DEVELOPMENT APPLICATION SEEKING A DEVELOPMENT PERMIT FOR A MATERIAL CHANGE OF USE – CENTRE ACTIVITIES (SHOP) OVER LAND AT 63 – 69 MACGREGOR TERRACE, BARDON QLD 4065 PROPERLY DESCRIBED AS LOT 92 ON RP213399, LOT 1 ON RP42301 LOT 96 ON RP20444 AND LOT 98 ON RP20444 – S50 AND S51 PLANNING ACT 2016

RESPONSE TO ADVICE NOTICE ISSUED UNDER SECTION 35 OF THE DEVELOPMENT ASSESSMENT RULES V1.3

63 MACGREGOR TCE BARDON QLD 4065 TRAFFIC ENGINEERING RESPONSE TO SARA INFORMATION REQUEST

Figure 1-3 SIDRA Network Layout – MacGregor Terrace / Site Access and MacGregor Terrace / Pedestrian Crossing

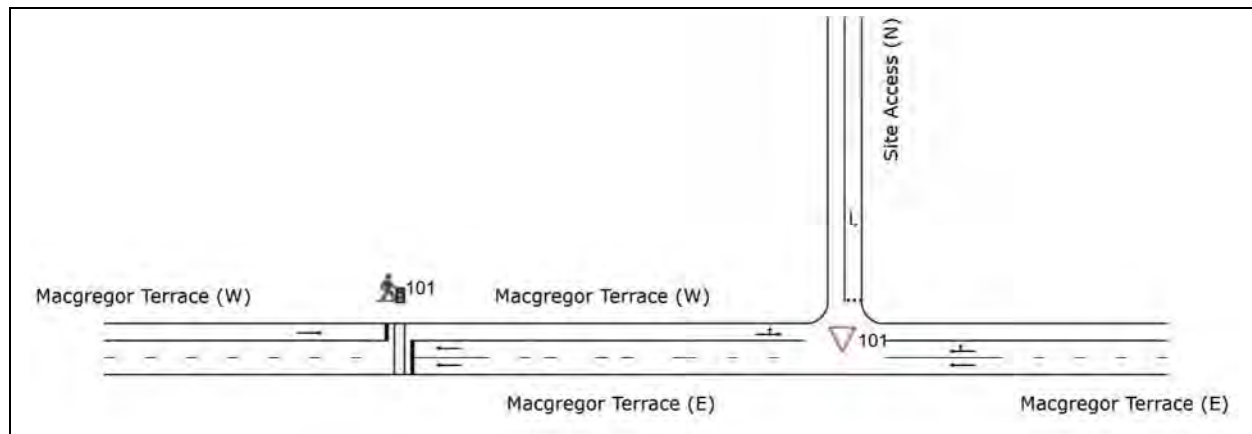
To further demonstrate the impact on the external road network, a SIDRA assessment has been undertaken of the development access point networked with the pedestrian signals to the west of the access point. Traffic assumptions and characteristics for this assessment are outlined in Appendix 4.

The configuration of the driveway crossover operates similar to a three-way unsignalised intersection. Due to the proximity of the signalised pedestrian crossing, this intersection has also been analysed. The SIDRA assessed layout is illustrated on Figure 1-3.

The proposed permitted movements have been assessed, with vehicles seeking to exit towards the west taking a left turn to re-route around the MacGregor Terrace / Latrobe Terrace intersection.

The results of the SIDRA network assessment are summarised in Table 1-3 and Table 1-4 for the network. Table 1-3 presents the SIDRA results for the MacGregor Terrace / Site Access intersection while Table 1-4 presents the SIDRA results for the MacGregor Terrace / Pedestrian Crossing.

Supermarket Macgregor Terrace Access Review Driveway Concept			
Drawn T.Anang	Date 30/11/2020	Scale 1:250	Size A3
Drawing Number SK16			Revision C

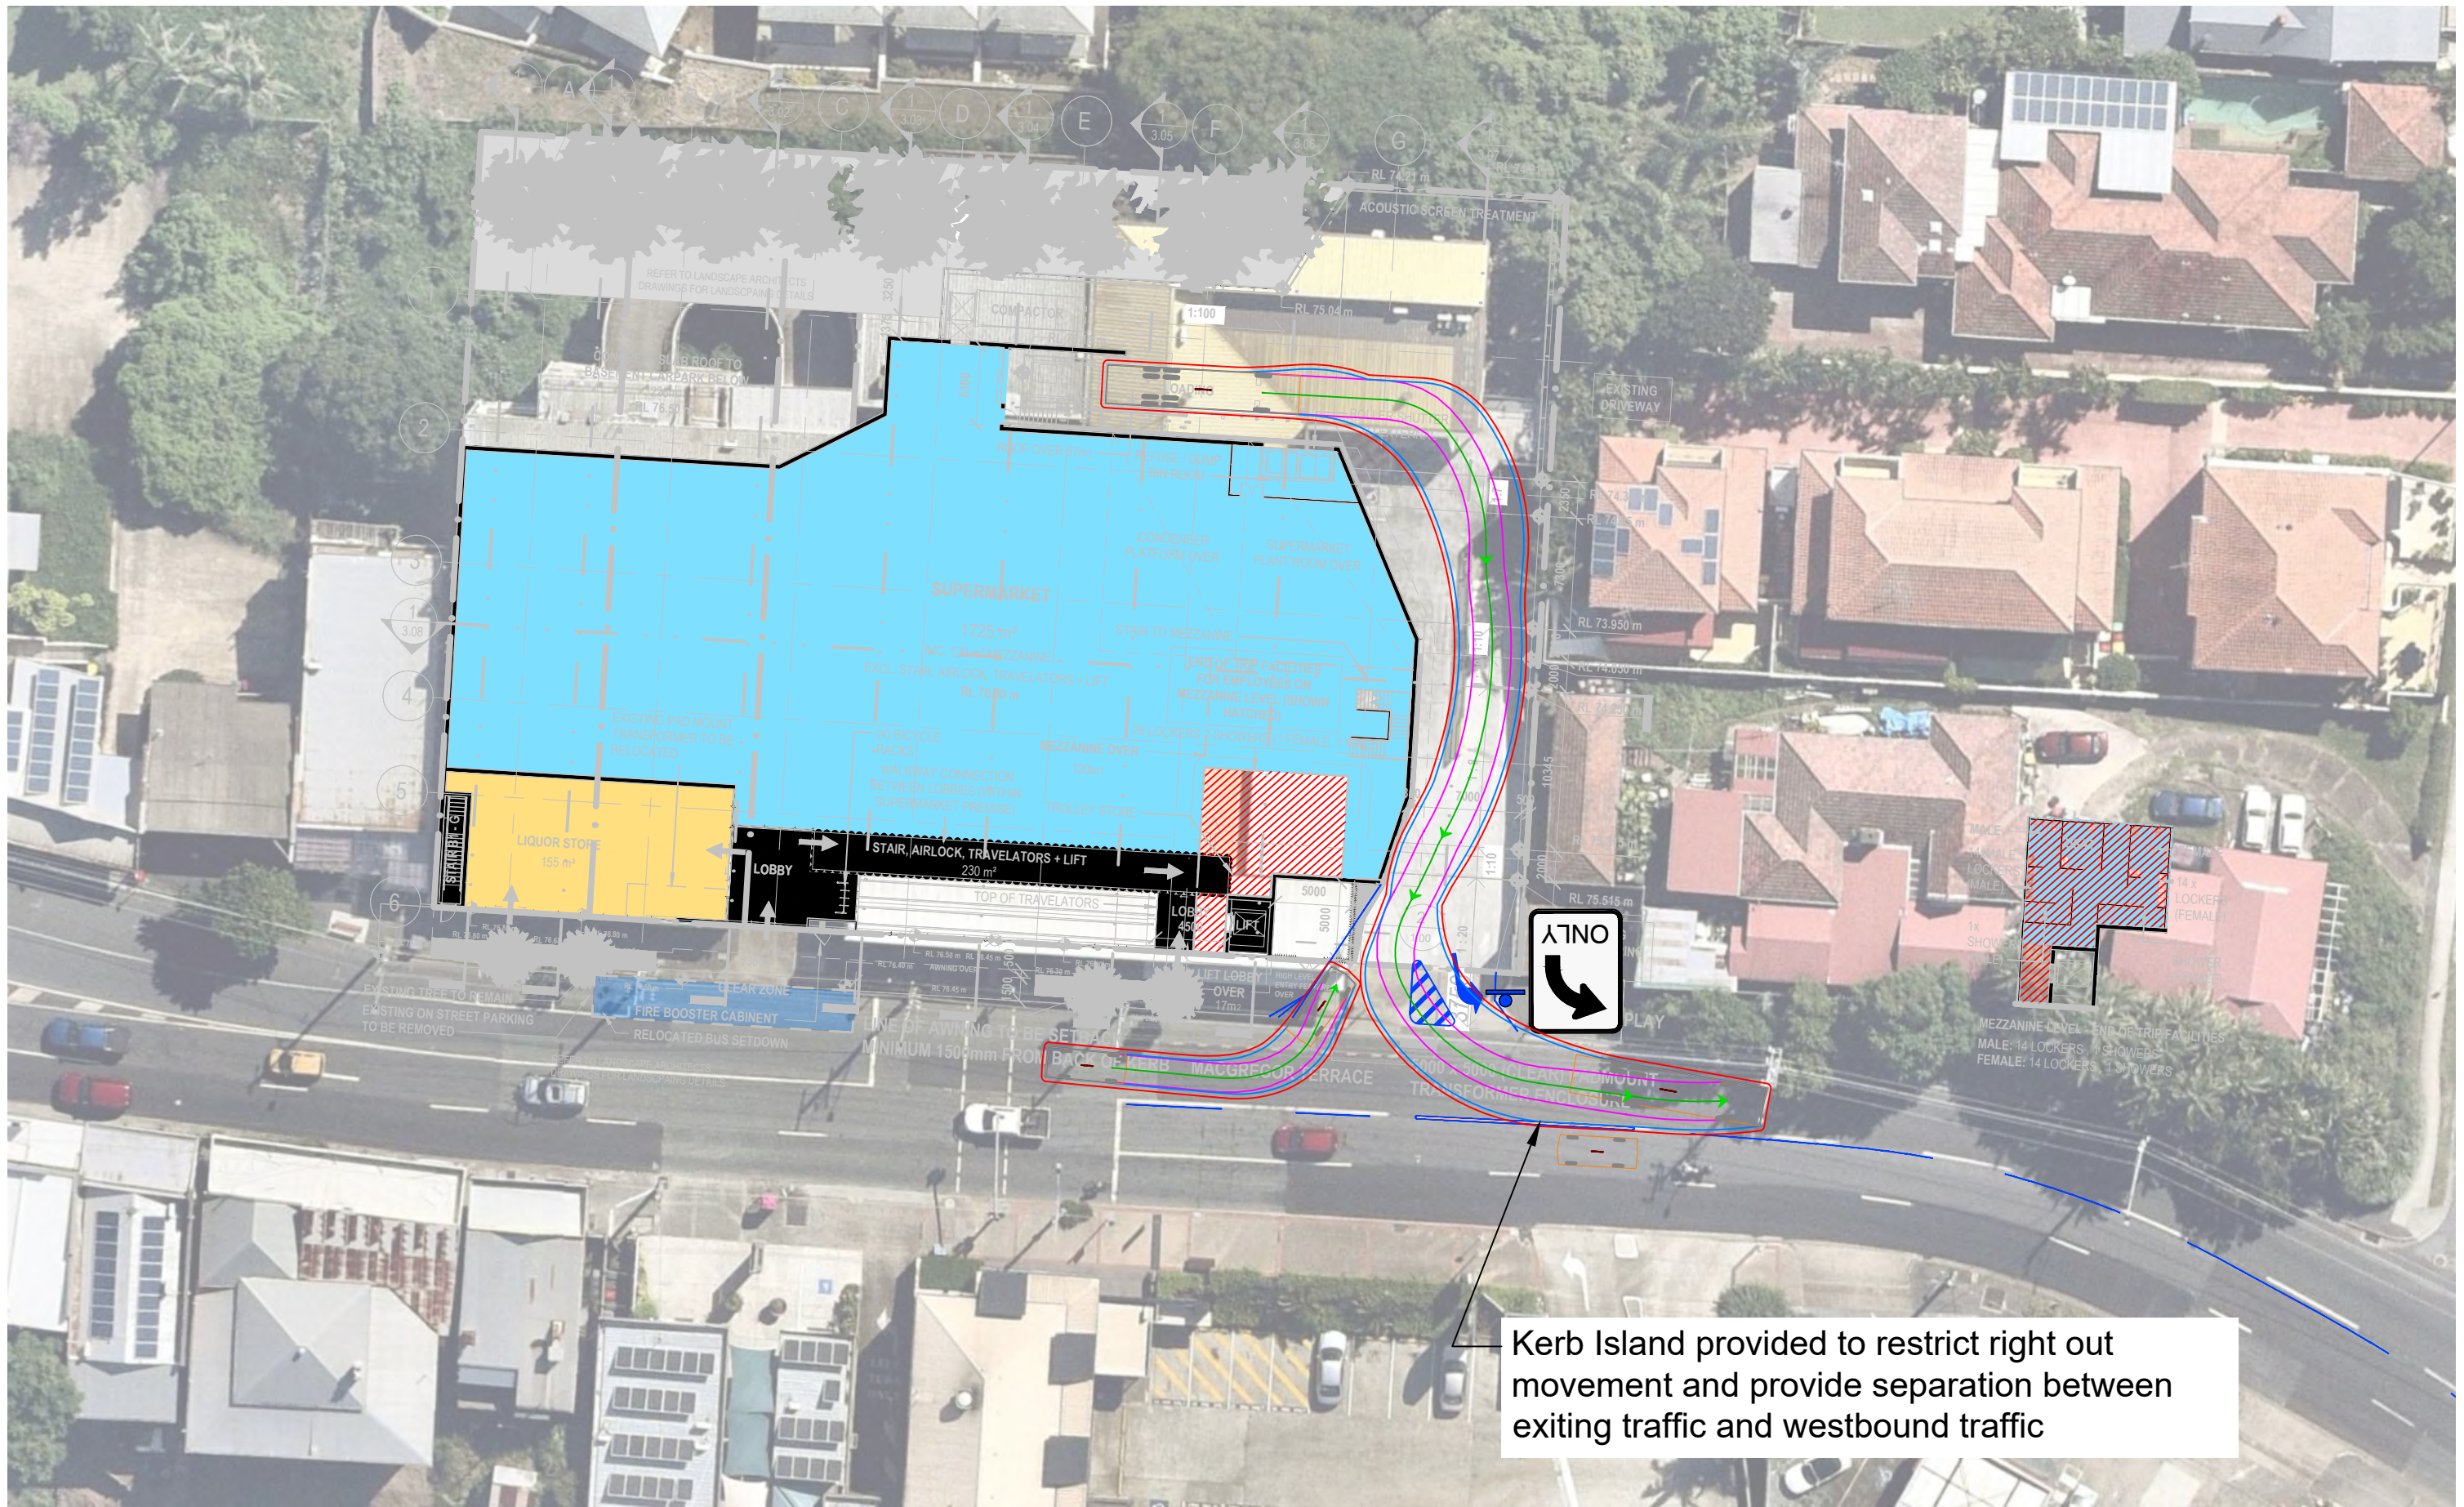
The response to information request stated that the proposed driveway has been widened to a 9m wide (hybrid type B1/B2) standard driveway to allow for simultaneous traffic movements through the access. The submitted swept path diagrams, prepared by Cardno, do not demonstrate that a Heavy Reticulated Vehicle (HRV) can safely manoeuvre through the access whilst facilitating simultaneous traffic movements within the access. Furthermore, the swept path diagrams show that an HRV turning left out of the site to Macgregor Terrace would utilise the entire width of the 9m driveway, as well as crossing over the road centre line.

It is required that the access driveway be redesigned to a suitable standard which provides safe, efficient and simultaneous traffic movements for all design vehicles, so as to comply with Performance Outcome (PO) 16 of State Code 1: Development in a State-controlled road environment (State Code 1) of SDAP.

- revised plans detailing a redesign of the proposed driveway that is suitable in providing simultaneous traffic movements for all expected vehicles (previous information request suggested a 12m wide Type C2 driveway be investigated).*
- revised swept path diagrams detailing that an HRV can safely manoeuvre and exit the access when a vehicle is queued at the access waiting to exit (ensuing no hazard impact)*

Following the advice by the Department of Transport and Main Roads (DTMR) the design team has updated the development plans to provide a 10.8 metre wide driveway crossover. A copy of the revised development plans is enclosed at Appendix 2.

The increased driveway width allows for heavy vehicles to safely pass any queued vehicles on both entry and exit. The revised swept path assessment indicates a vehicle is able to store without impacting the through traffic on MacGregor Terrace while the HRV leaves the site. This is indicated on drawing QTT20017-SK18-D, which also outlines that the HRV exit manoeuvre sits within the provided lane width of MacGregor Terrace and provides sufficient clearance (500mm) to vehicles travelling on the opposite side of MacGregor Terrace (westbound).

This arrangement demonstrates that while the HRV is exiting the site, a B99 is able to store across the access, while remaining outside of the through traffic lane. While the vehicle is shown propping across the verge, traffic on MacGregor Terrace will not be blocked from continuing through, as it will only be positioned temporarily, until the HRV exits the site. Pedestrians will be able to clearly see the vehicle waiting and therefore, the risk of conflicts occurring is considered to be unlikely.

The redesigned access also provides a small central median on MacGregor Terrace, which blocks right turn manoeuvres out of the site and separates left turn manoeuvres out of the site from westbound traffic on MacGregor Terrace. The central median ensures HRV drivers would be able to perform the left turn exit manoeuvre within the eastbound lane width of MacGregor Terrace as the physical barrier provides a limit to the manoeuvring area.

Provide 14m median island by reducing outside lane width to 3.3m (0.2m reduction)

Figure 2-2 MacGregor Terrace / Midblock Pedestrian Crossing Intersection Phasing

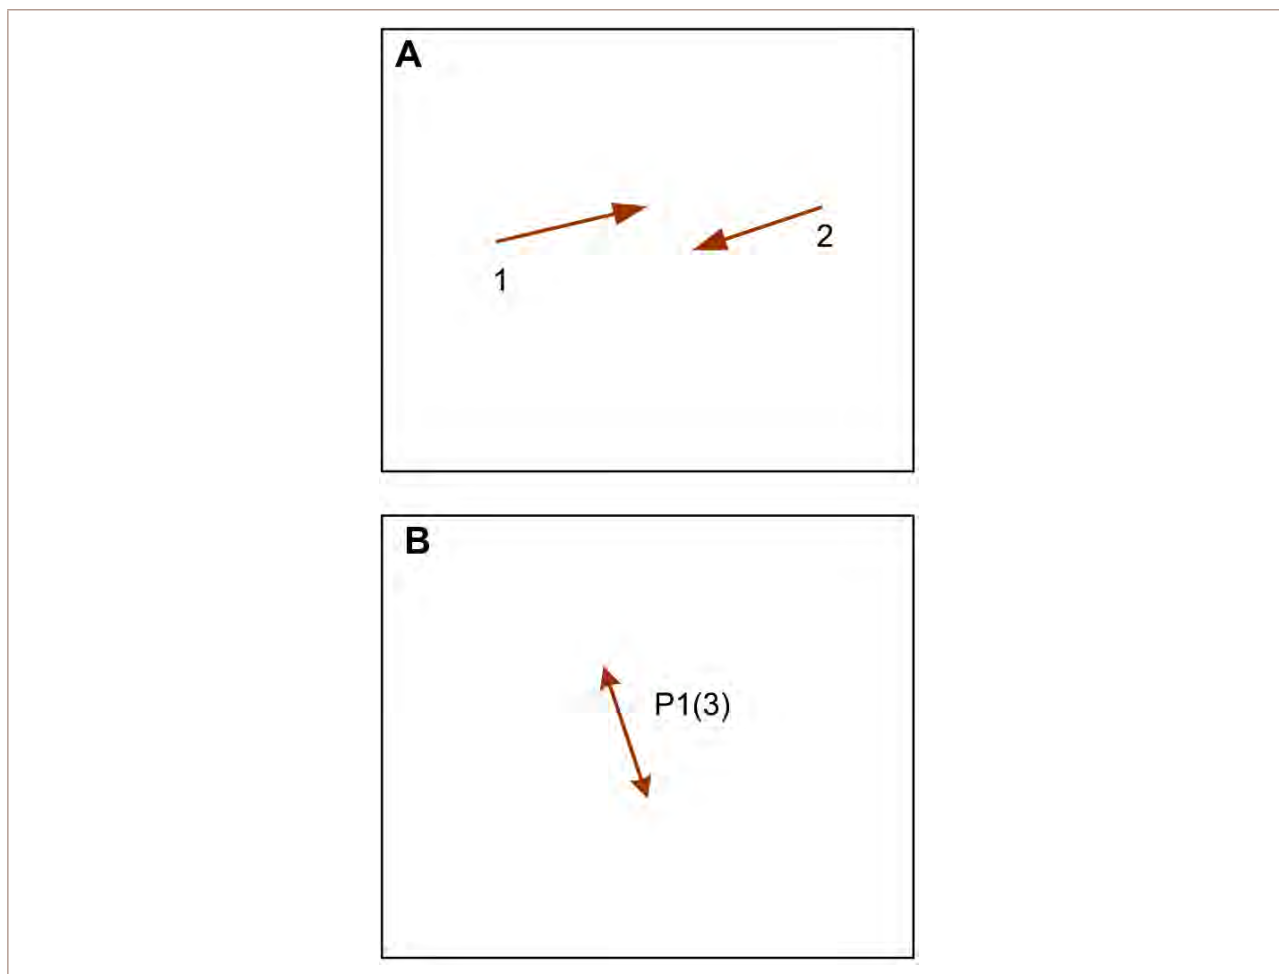
SARA has also requested further information on the pedestrian crossing phases at the MacGregor Terrace / Midblock Pedestrian Crossing intersection. The BCC Phasing for the intersection is illustrated in Figure 2-2.
